SUBJECT: Second Review of HPC Case No. 31/6-90M (10312 Armory Avenue,
Kensington)

HISTORIC PRESERVATION COMMISSION STAFF REPORT

CASE NUMBER: 31/6-90M

PROPERTY ADDRESS: 10312 Armory Avenue

Pantry window - used to be
back door. Note unmatchd
siding. Would like to enlarge
this window to same size
as others on ground floor.

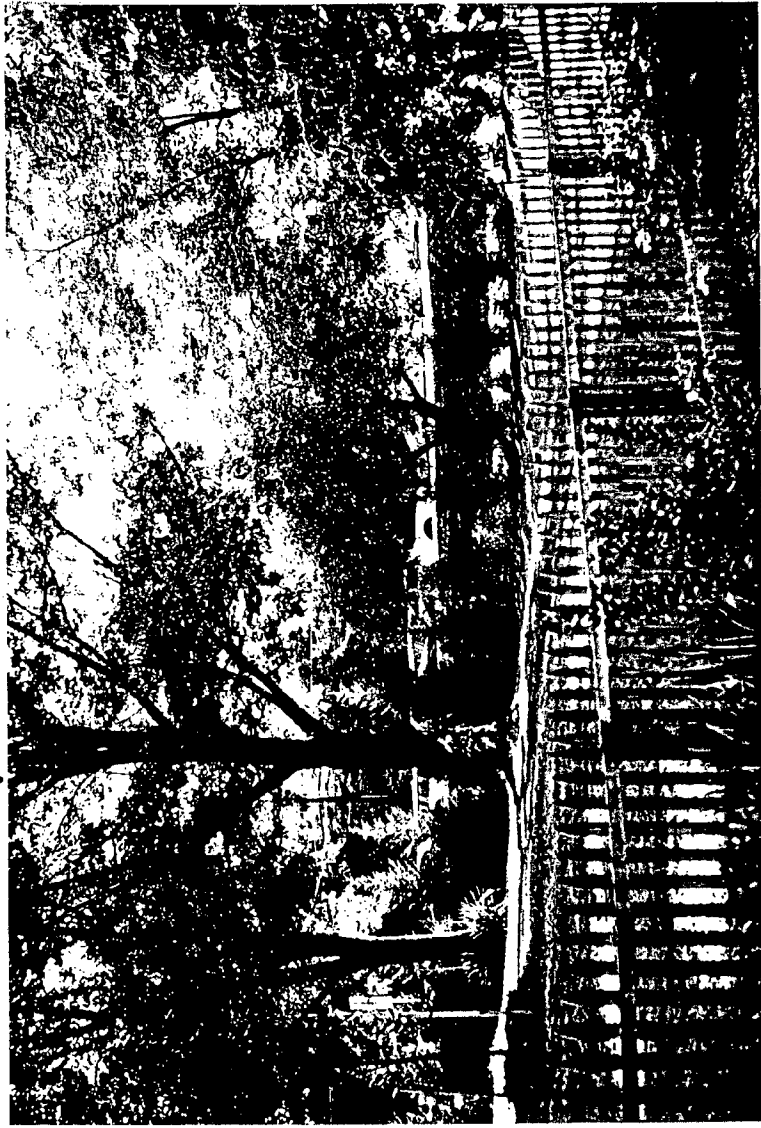
Staff also recommends approval of the applicants' proposal to enlarge an existing small window on the south elevation based on criterion 24A-8(b)(1). The existing small window is not original to the house and the proposed window would be equal in style and size to the remaining windows.

1. Proposed bay window on south elevation: We believe that the addition of a bay window would adversely impact the highly visible south side of the house. We have decided to delete this feature from the proposed design. We would, however, like to enlarge the small window that is located to the rear of the house in order to match the other windows on the south side and provide more light into what is to become a family room. This window is not an original feature of the house but was added on sometime in the 1940s when a side door was moved to the rear of the house.

SOUTH ELEVATION

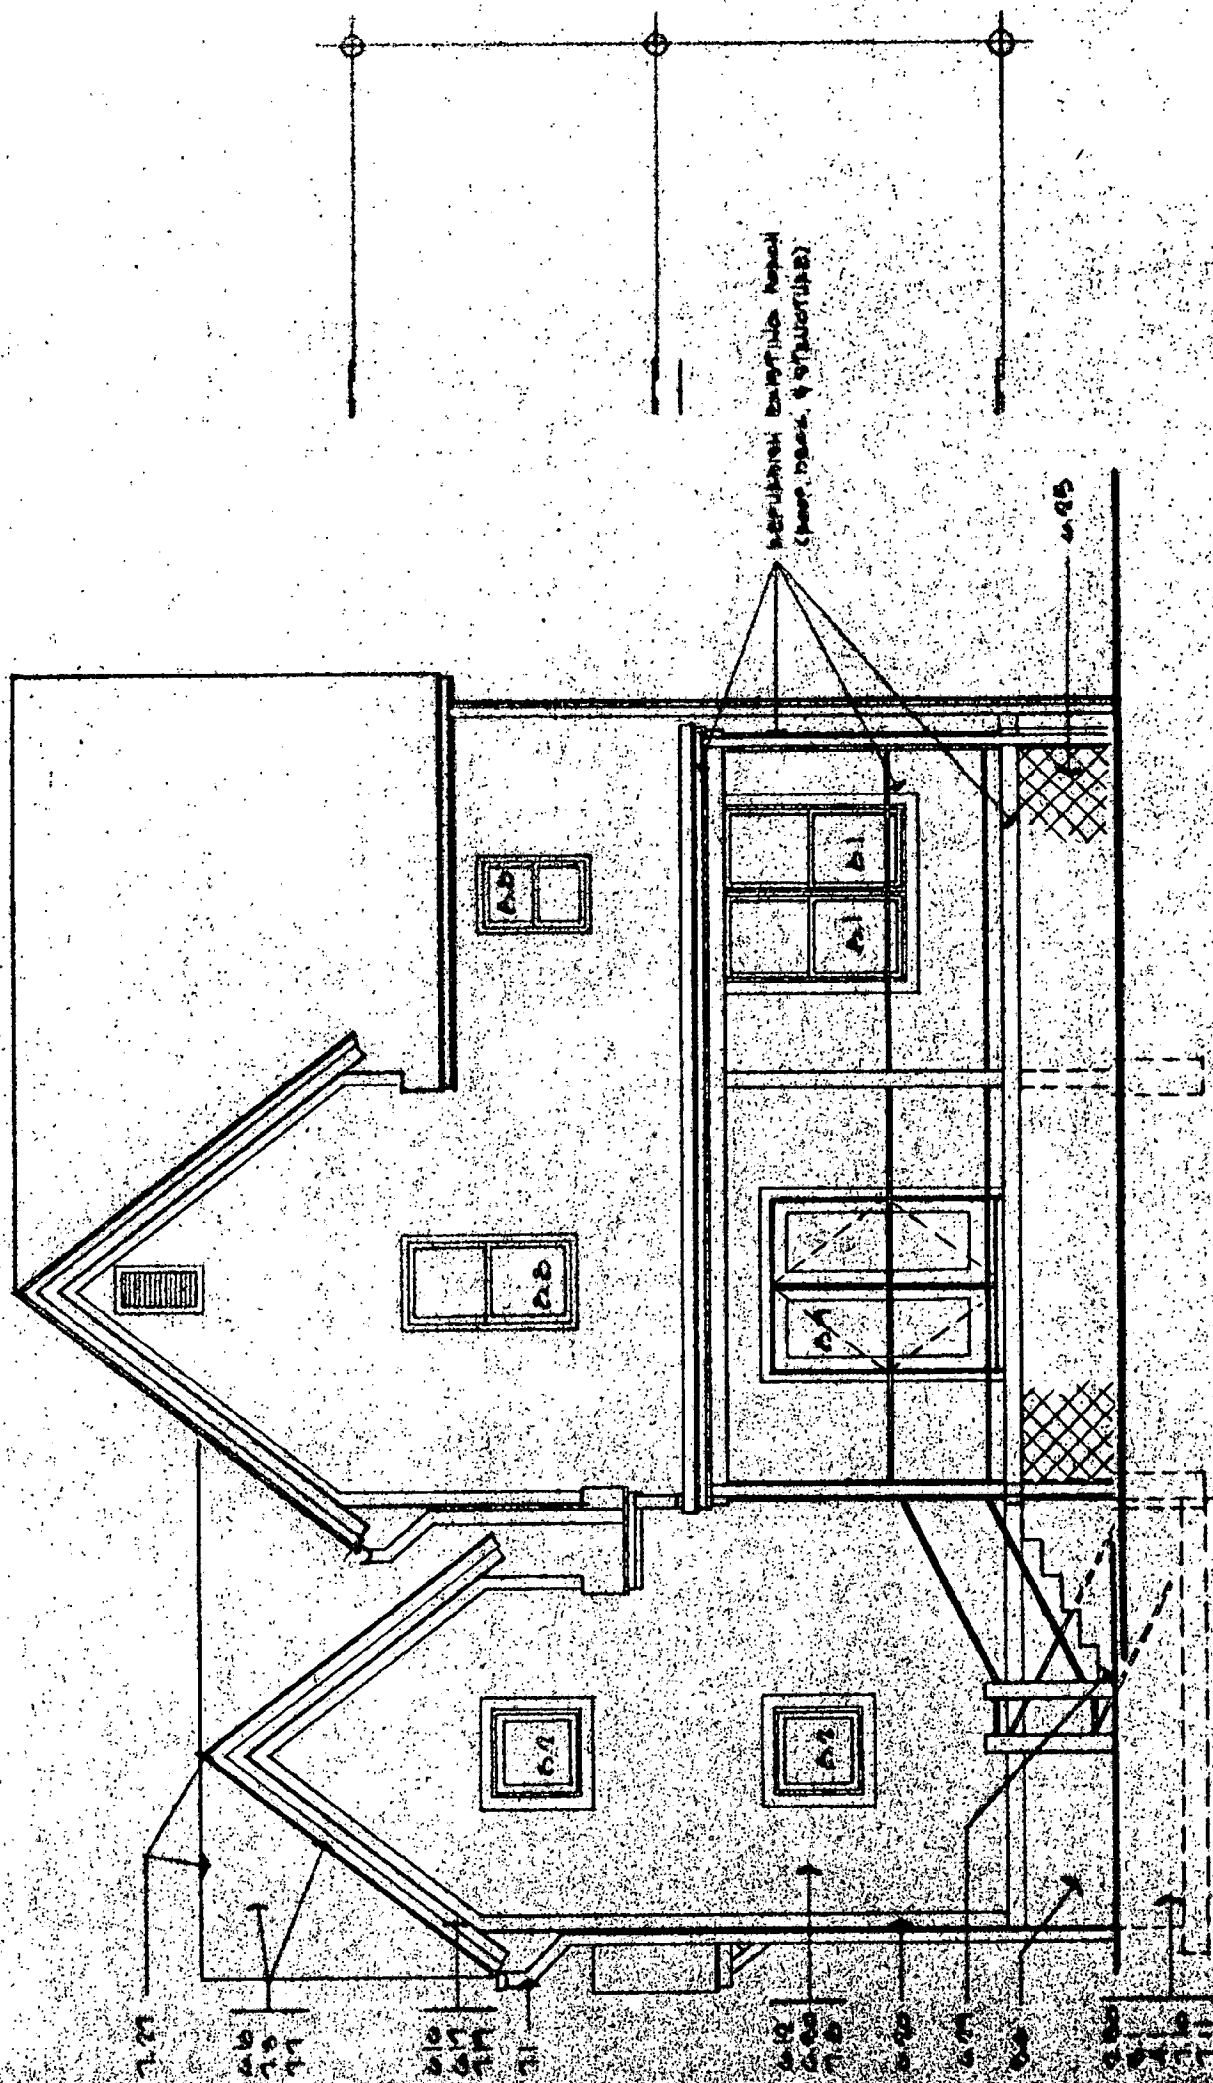
1. The appropriateness of the bay window on the south elevation
2. The appropriateness of constructing the addition in the side yard, as opposed to another location;
3. The appropriateness of the streetwall to be created by the proposed addition. Commission members questioned whether it might be more appropriate to site the addition, should it be constructed in its proposed location in the side yard, further back from the street;
4. The amount of space between the house and the adjacent resource, and whether reduction in that space would adversely affect those structures, the streetscape, and ultimately, the integrity of that part of the Kensington Historic District; and
5. The presentation of the half-circular back porch, and how it would present itself three dimensionally.

1. The appropriateness of the proposed bay window on the south elevation;
2. The appropriateness of constructing the addition in the side yard, as opposed to another location;
3. The appropriateness of the streetwall to be created by the proposed addition. Commission members questioned whether it might be more appropriate to site the addition, should it be constructed in its proposed location in the side yard, further back from the street;
4. The amount of space between your home and the adjacent resource, and whether reduction in that space would adversely affect those structures, the streetscape, and ultimately, the integrity of that part of the Kensington Historic District; and
5. Finally, the Commission was concerned with the presentation of the half-circular back porch, and how it would present itself three dimensionally.

1. Deletion of proposed bay window on south elevation; new proposal to enlarge existing small window to size equal to existing windows.
2. Slight setback (18") of side addition from front elevation.
3. Deletion of half-circular back porch addition.

ARMORY AVENUE STREETSCAPE W/ PROPOSED ADDITION

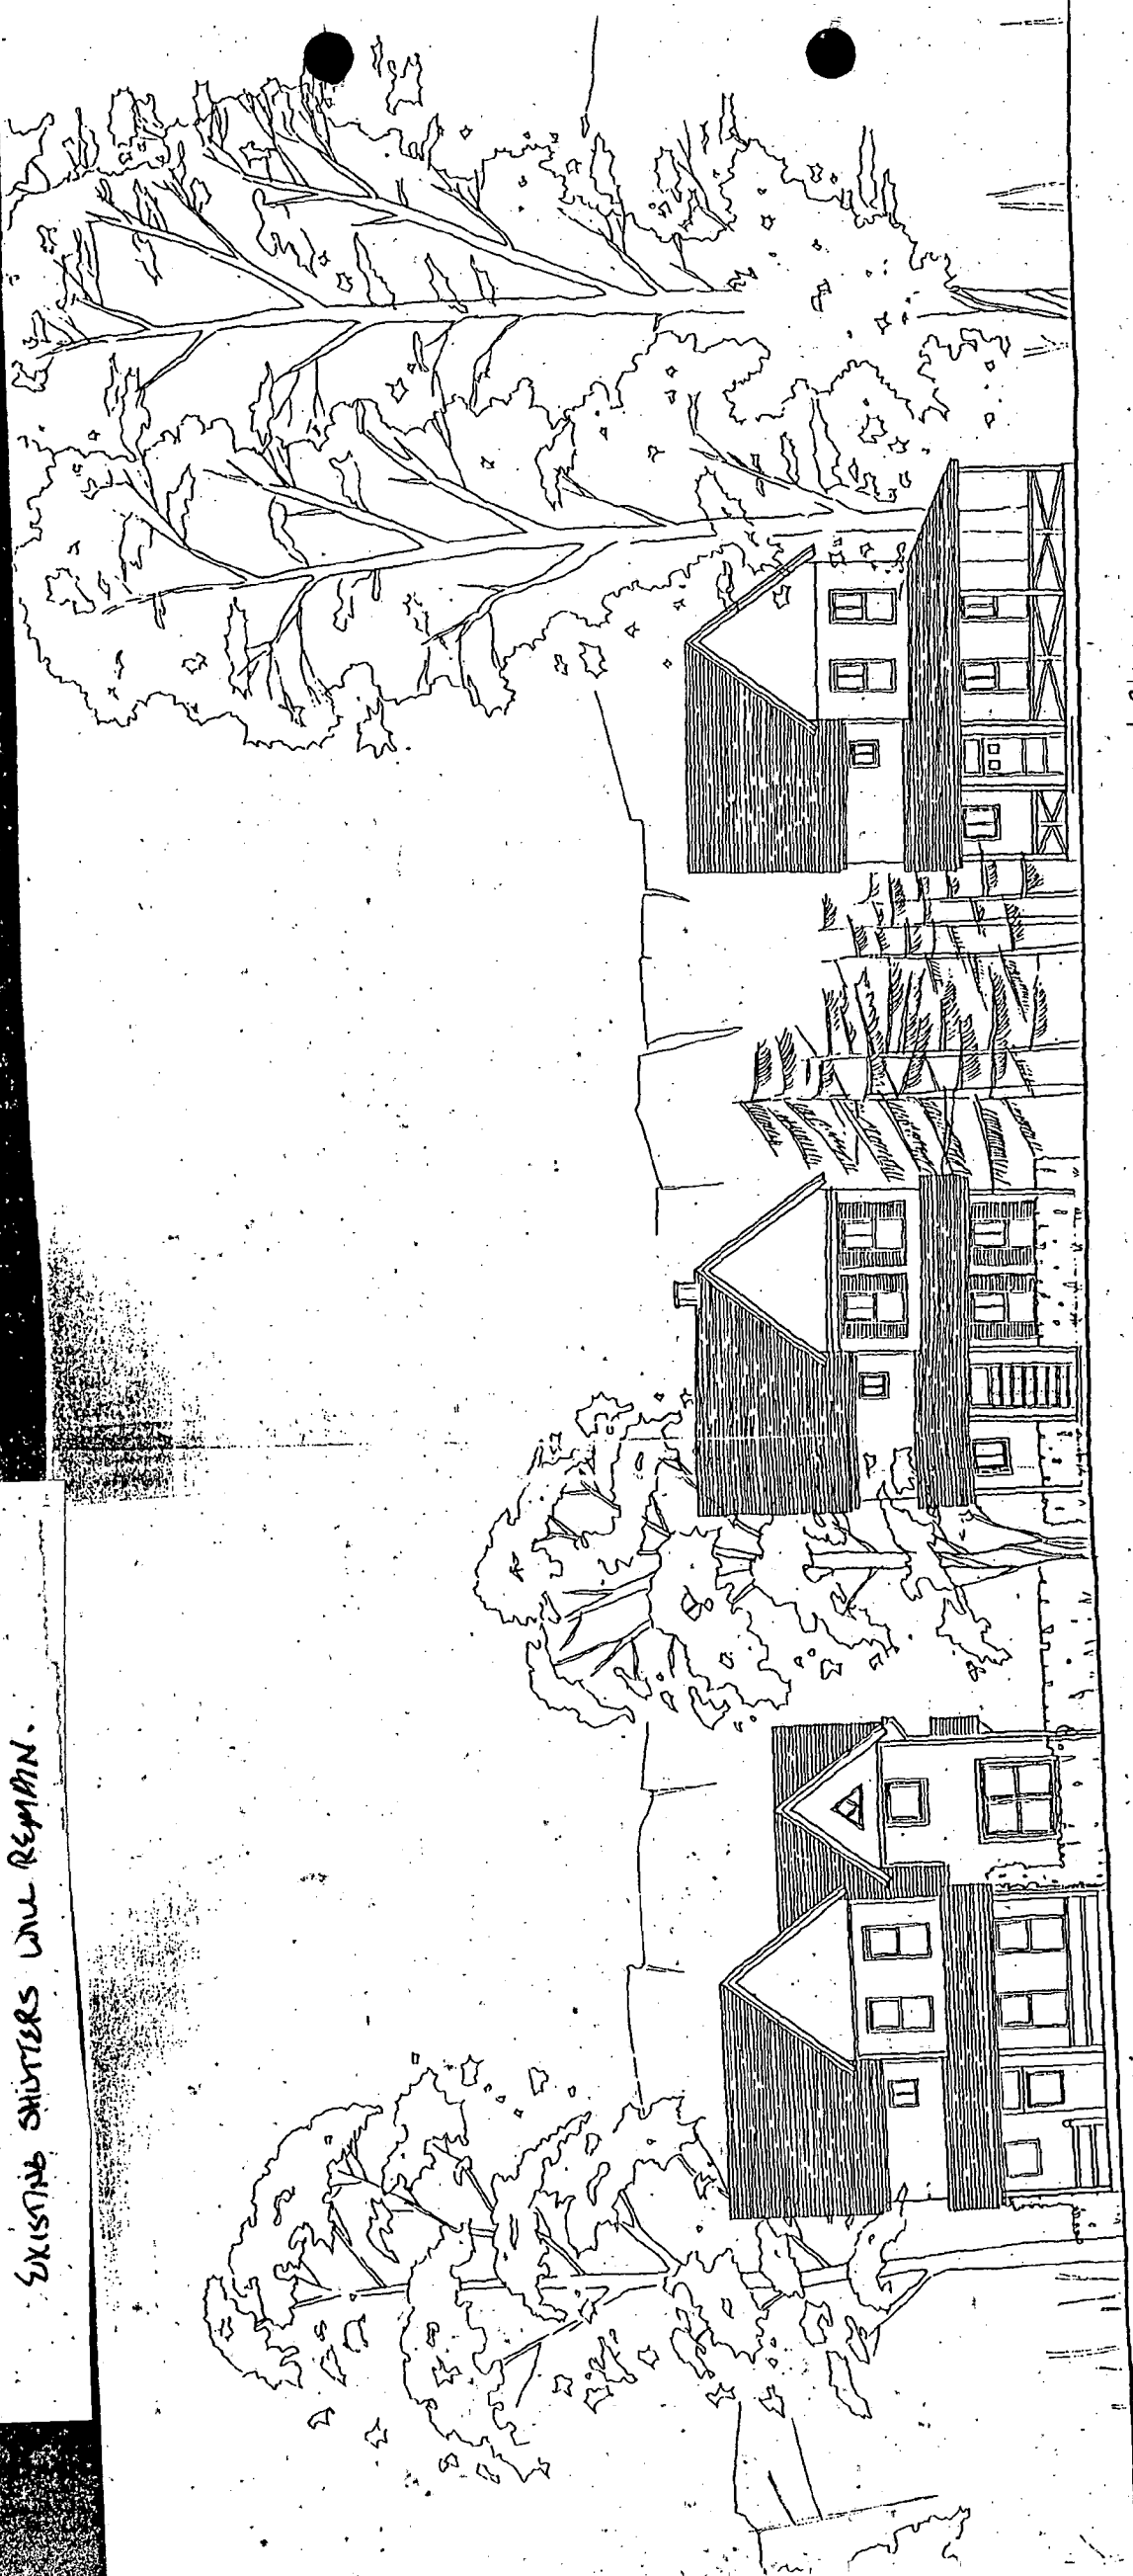
3. Appropriateness of the streetwall: The proposed design currently includes an offset feature which is an eighteen inch indentation on the front facade. We agree with the Commissioners that a more distinct offset may be helpful to reduce any perceived impact on the streetscape to the east side of the house. We are proposing now that the entire addition be set back eighteen inches from the main part of the house. In addition, as a means to further minimize visual impact, we propose to landscape the area in front of the addition with plants and shrubs.

The Commission has also specifically requested that a streetscape elevation of Armory Avenue be provided, in addition to a simple model to help it better visualize the proposal.

NOTE: EXISTING SHUTTERS ON 10312 ARMORY AVENUE
WERE INADVERTENTLY LEFT OFF OF DRAWING.
EXISTING SHUTTERS WILL REMAIN.
